## SERVICE BULLETIN

No. 300-1-06

- Subject:** **Repositioning of Single Oil Cooler**
- Affected Aircraft:** EA 300/S and EA 300/L aircraft equipped with the single oil cooler system manufactured before May 2006.

Fig. 1: Oil cooler, typical crack locations

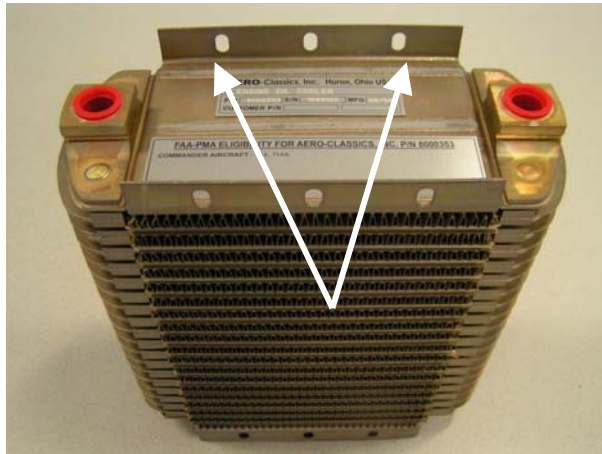
- Purpose:** Cracks have been reported on EA 300/S and EA 300/L airplanes equipped with the single oil cooler system. The cracks were found in the RH AFT engine cooling baffles where the oil cooler is attached to or in the oil cooler flanges. This Service Bulletin provides instructions for repositioning of the single oil cooler from the cylinder cooling baffles to the engine mount. Refer to Figure 7 for an overview.

- Disconnect battery ground wire and engine ground wire to firewall.
- Disconnect and remove oil cooler.
- Check oil cooler for cracks, especially around the attachment flanges, see Figure 1.

Fig. 2: Front View Current Oil Cooler Installation.

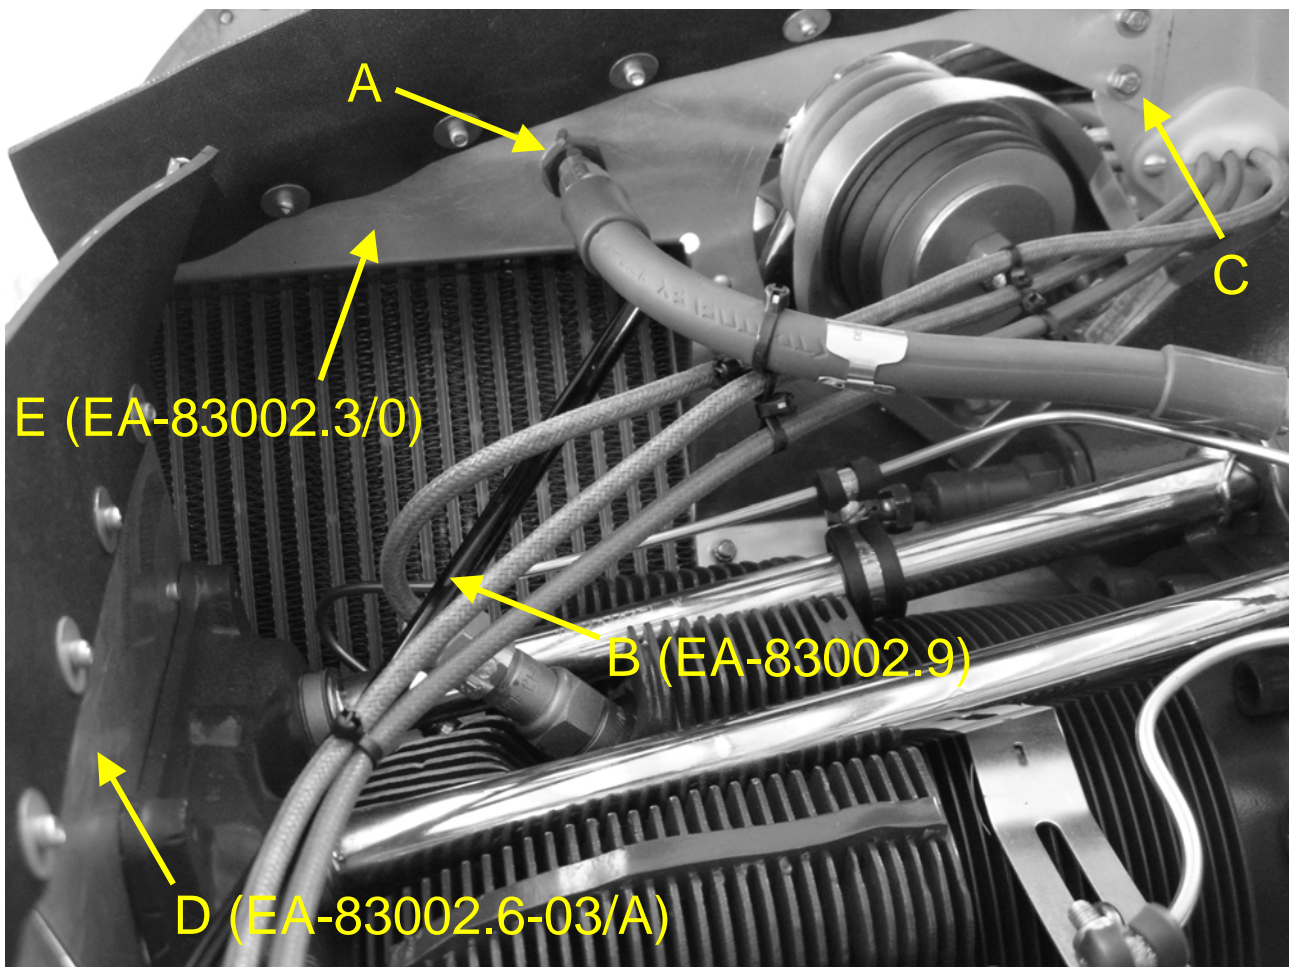
- Disconnect fuel sensing lines at RH AFT cooling baffle and remove bulkhead fitting, point A in Figure 2 (the AN832-4D bulkhead fitting is not needed for the new installation).

- Remove rod EA-83002.9, point B in Figure 2 (not needed for the new installation).
- If installed, also remove reinforcement rod on outside head cooling baffles, see Figure 7 (not on all aircraft, not needed for new installation).

- Remove bolts connecting the AFT middle baffle (P/N EA-83002.7) to the RH AFT baffle (P/N EA-83002.3), refer to connection C in Figure 2. Disconnect the threaded rods on the underside from the RH AFT baffle (P/N EA-83002.3), see Figure 4.

- Remove baffles EA-83002.6-03 index A and EA-83002.3 index 0 including attached rubber flanges, respectively points D and E in Figure 2 (not needed for the new installation). Pre-cut the rubber flange attached to the cylinder head baffles between Cylinders No.3 and No.5 just FWD of the most FWD rivet position on the baffle on Cylinder No.5, see Figure 4.

- Mark the position of the holes (for point C in Figure 2) in the middle baffle (P/N EA-83002.7) on the RH AFT baffle (P/N EA-83002.3). Remove assembled baffles and drill holes (Ø4mm / Ø5/32", Drill Size #21) in the marked locations in the RH AFT baffle (P/N EA-83002.3).

Figure 3: Side and top view of jig installation.

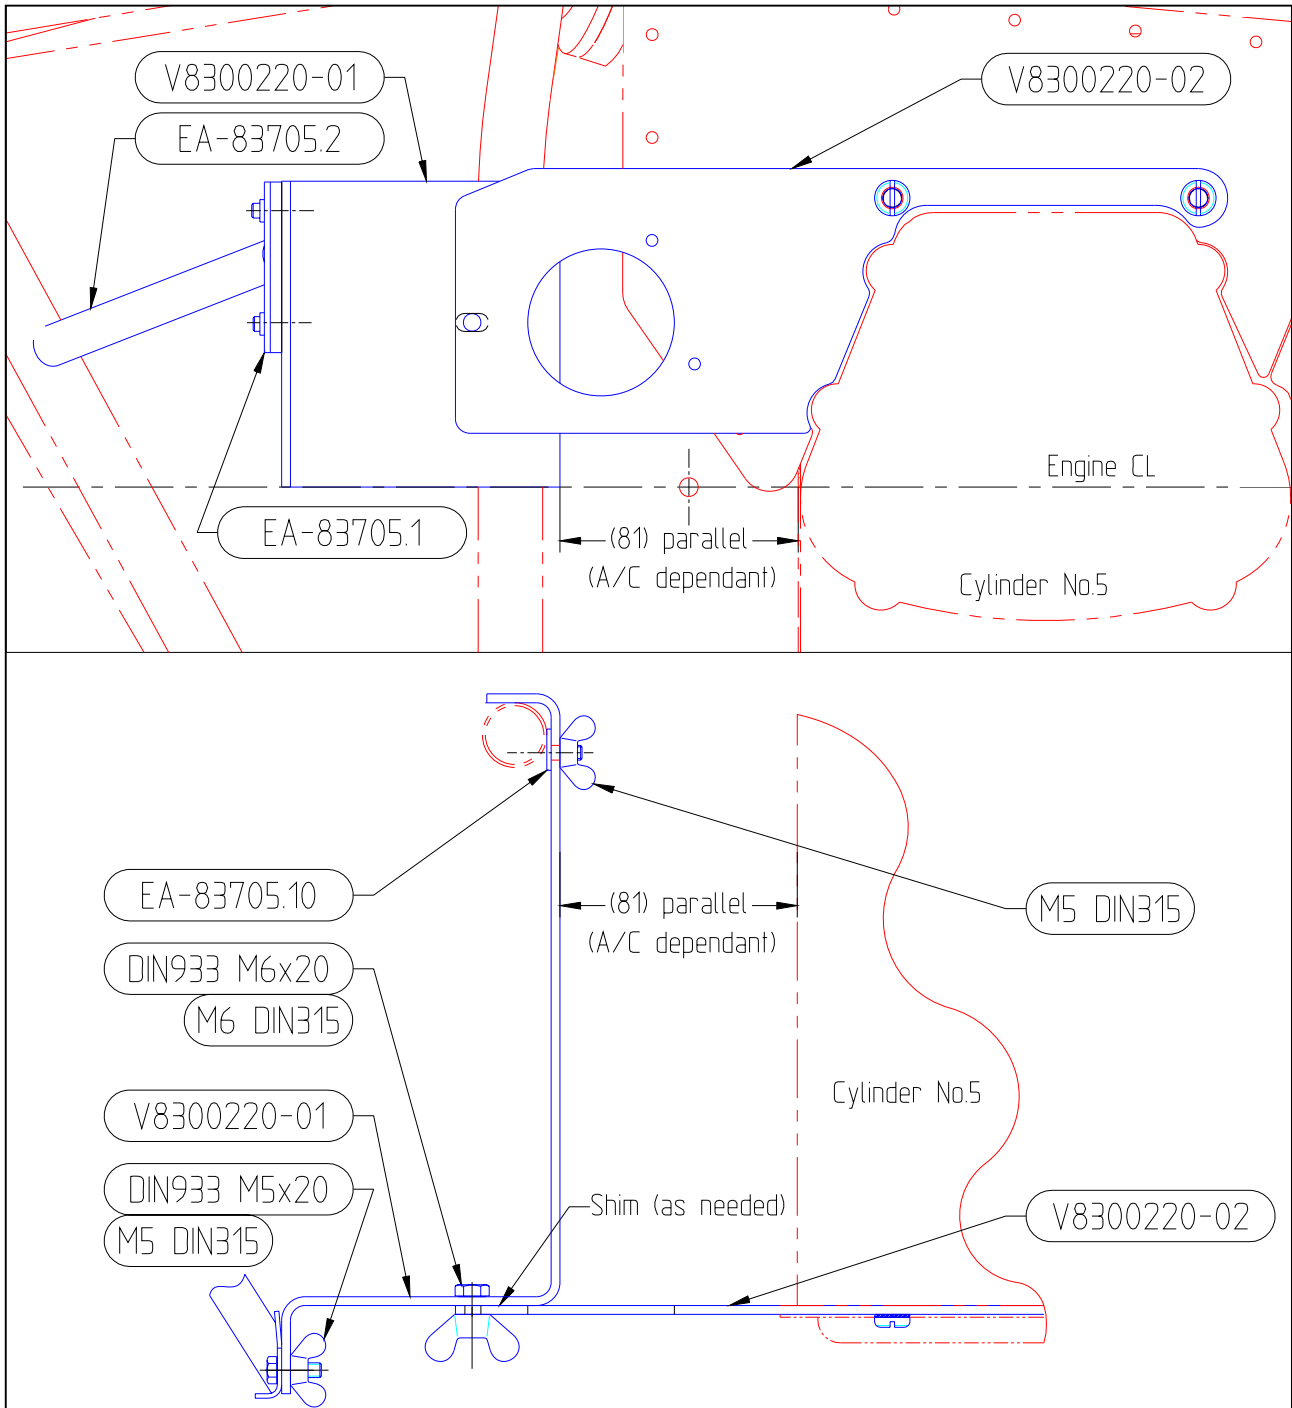
- Bolt the LH and the RH oil cooler attachment brackets (P/N EA-83705.10 & EA-83705.1) to the jigs (P/N V8300220-01 & -02) with the supplied wing nuts (P/N M5 & M6 DIN315). Install

jigs according to Figure 3. On some aircraft it may be necessary to shim the two jigs for correct alignment.

- Remove paint on engine mount in the areas where the new oil cooler LH oil cooler attachment bracket (P/N EA-83705.10) and tube (P/N EA-83705.2) will be welded to, see Figure 3 & 4.

- Spot weld the LH oil cooler attachment bracket (P/N EA-83705.10) to vertical tube of engine mount.
- Prepare the attachment tube (P/N EA-83705.2) to fit between the RH oil cooler attachment bracket (P/N EA-83705.1) and the engine mount according Figures 3 & 4. Check for enough space between tube and oil separator (temporarily installed for this purpose) and its fittings, see Figure 5. Here, the oil separator is installed rotated 15° CCW when viewed from above relative to its original position to provide enough separation between the middle fitting and the oil cooler. The upper fitting has to point in its original direction i.e. has to be rotated 15° CW when viewed from above.
